ADDENDUM NUMBER: Addendum - Two

VETERANS PARK SHELTER DEMOLITION

PROJECT NUMBER: P167-10422

DATE OF ADDENDUM: March 08, 2013

A-101 FIRST FLOOR DEMOLITION PLAN; KEYED DEMOLITION NOTES:

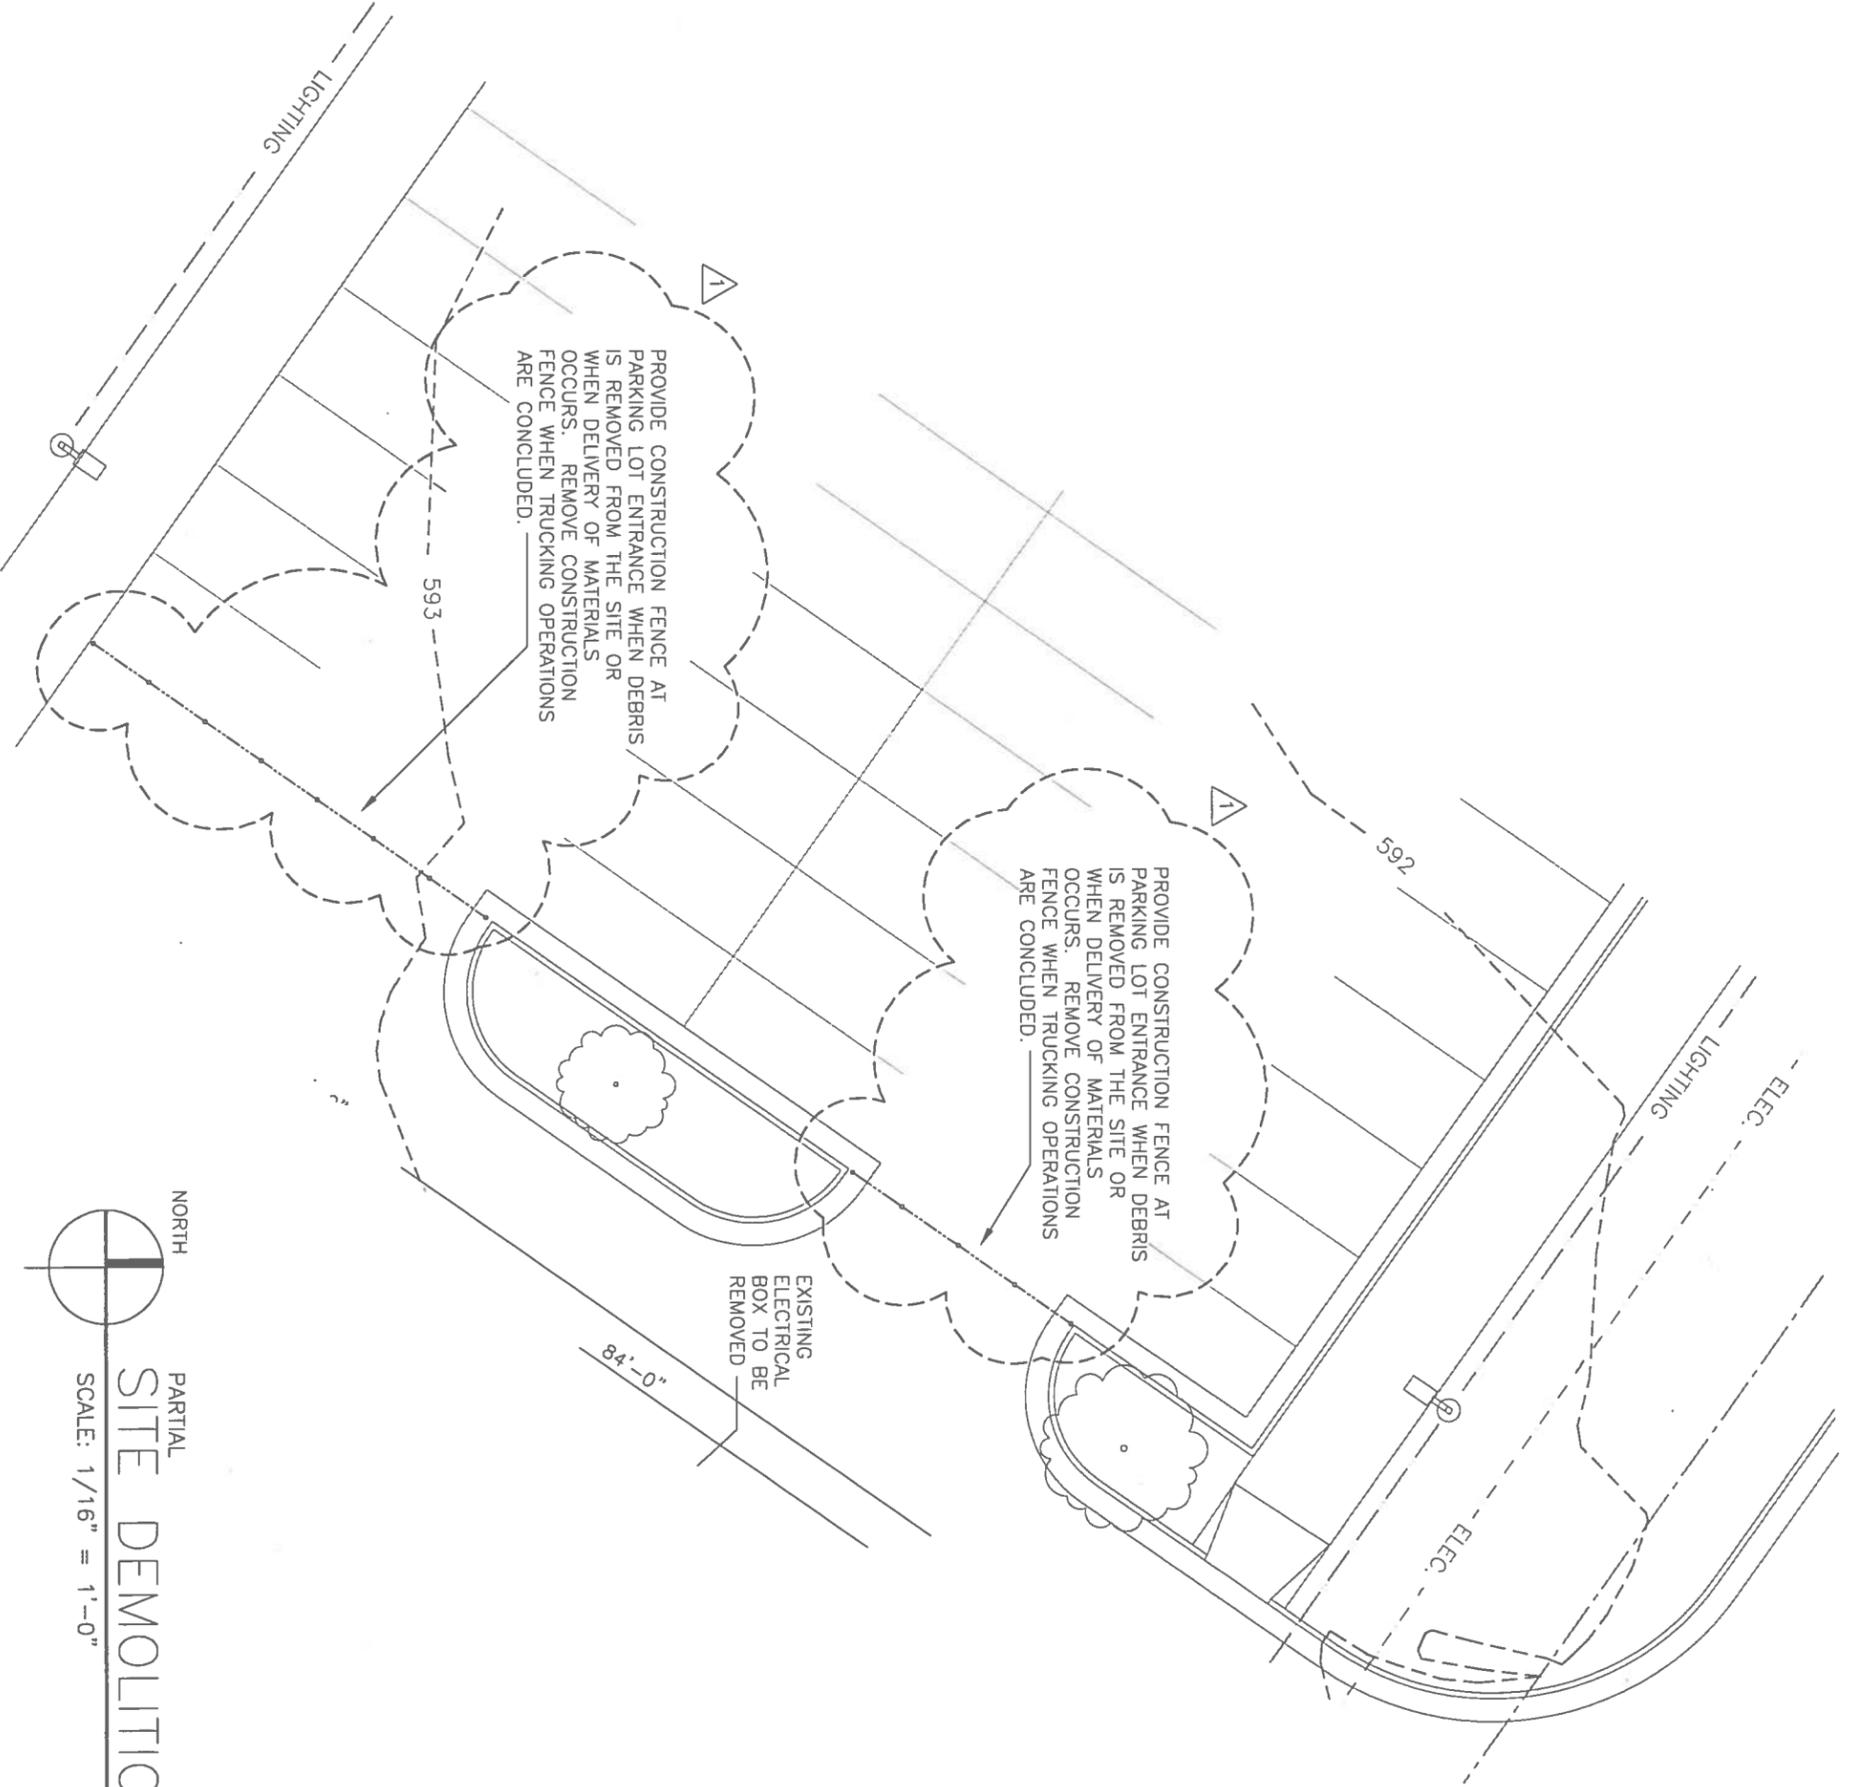
Revise Note 6: Remove and salvage for delivery to Owner existing toilet partitions, partition doors, and partition hardware.

Add note 12: Remove and salvage for delivery to Owner existing Modine electric heater, located in Utility Room (ceiling mounted).

Add note 13: Remove and salvage for delivery to Owner existing timers(two), located In Utility Room, north wall.

DATE: 03/08/2013
 PROJECT: P167-10422
 SITE NO.: 794
 BUILDING NO.: 1505
 SHEET NO.: ADD.2-1

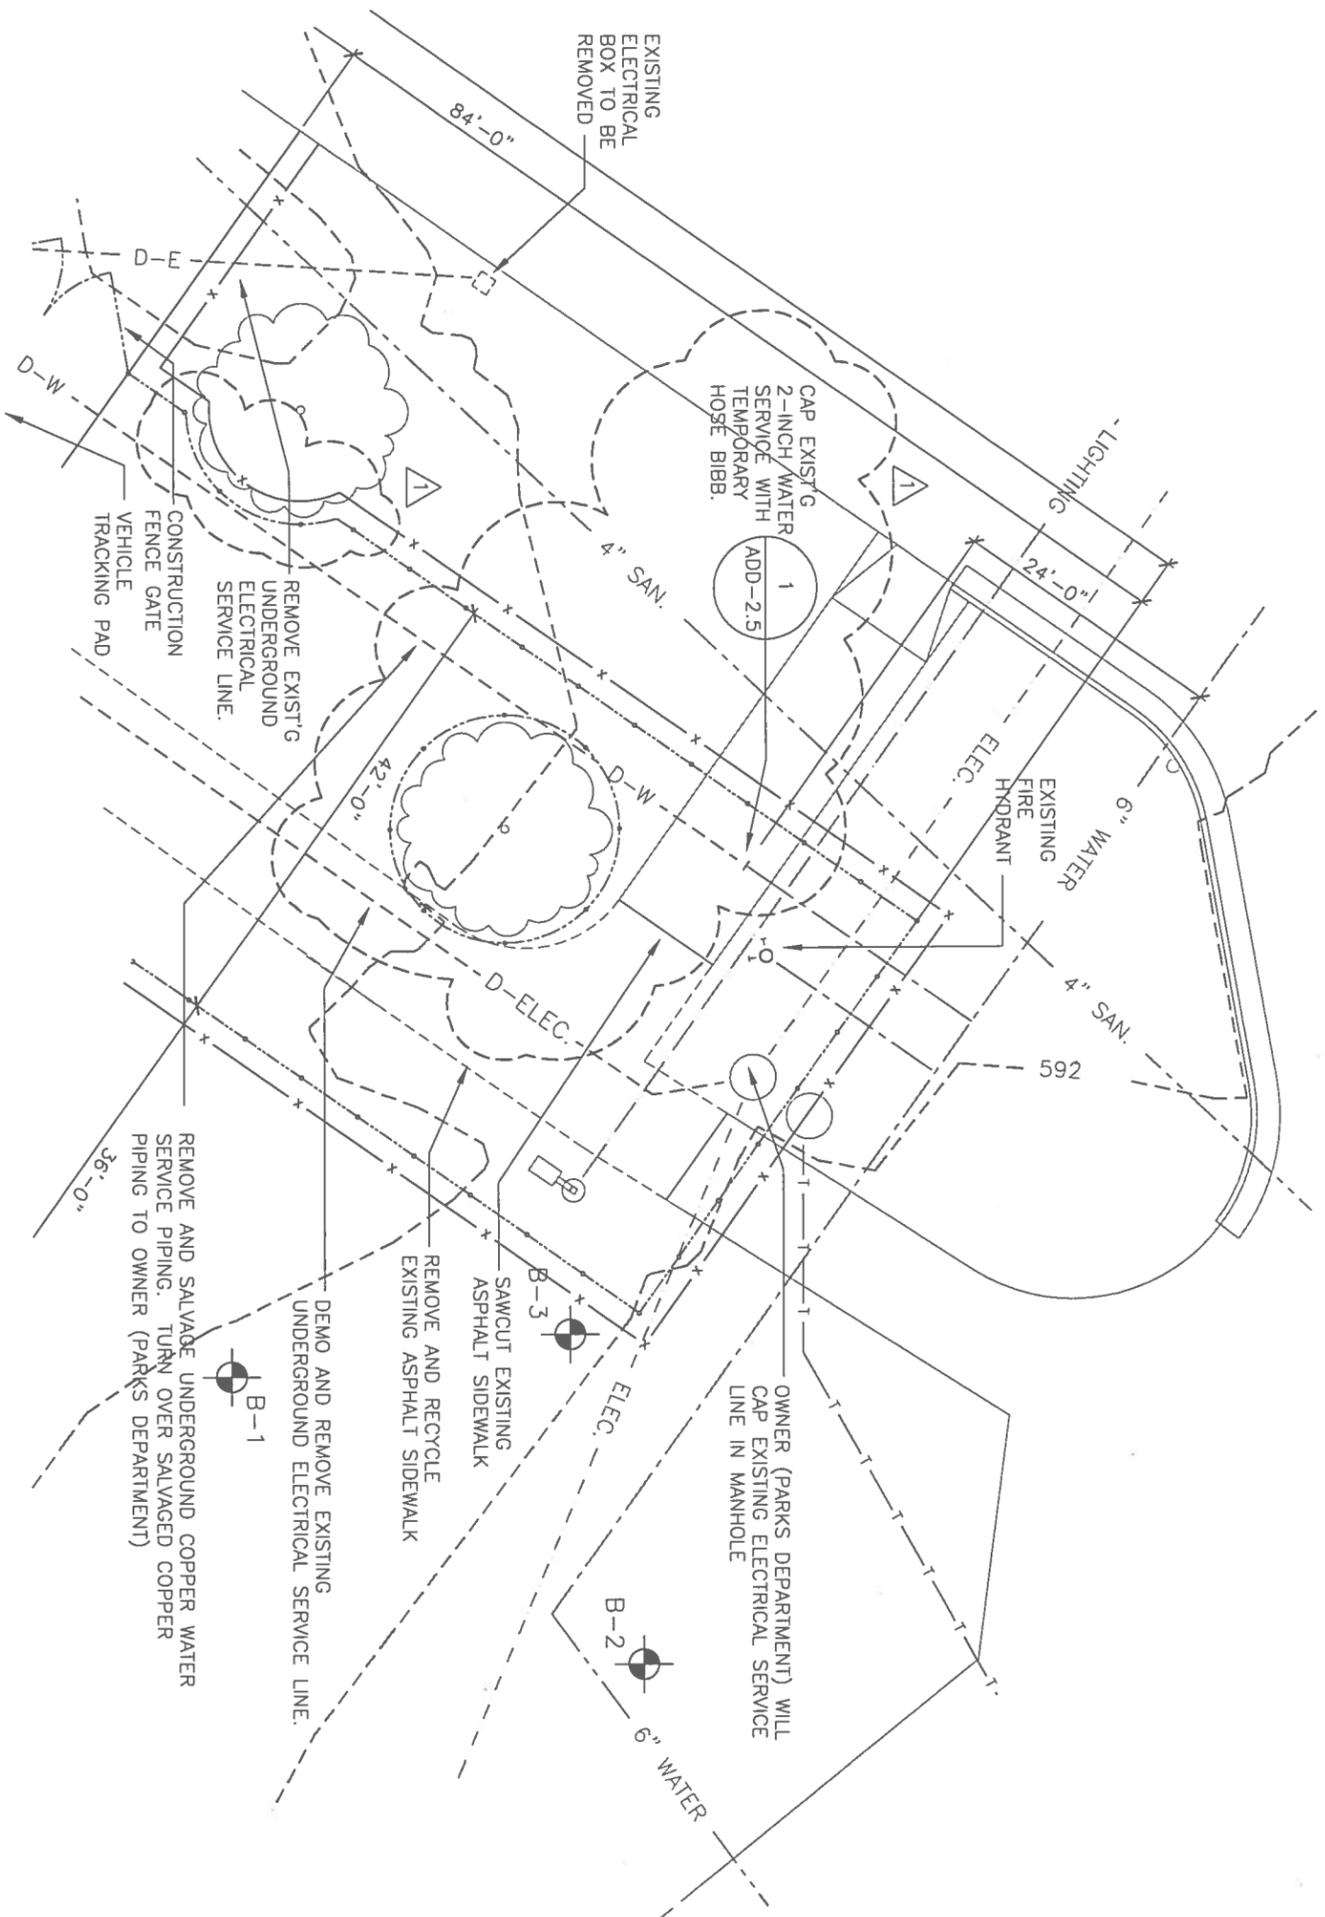
A-100 SITE DEMOLITION PLAN:
Revise Site Demolition Plan as indicated. See attached Partial Site Demolition Plans ADD-2.2 and ADD-2.3 for new construction fence layout.
Revise Site Demolition Plan as indicated. See attached Partial Site Demolition Plan ADD-2.1 for temporary barricades to block parking lot during trucking operations.
Revise Site Demolition Plan as indicated. See attached Partial Site Demolition Plan ADD-2.2 for added clean-out location. See attached detail, sheet ADD-2.4.
Revise Site Demolition Plan as indicated. See attached Partial Site Demolition Plan ADD-2.3 for added temporary hose bib location. See attached temporary hose bib enclosure detail, sheet ADD-2.5.
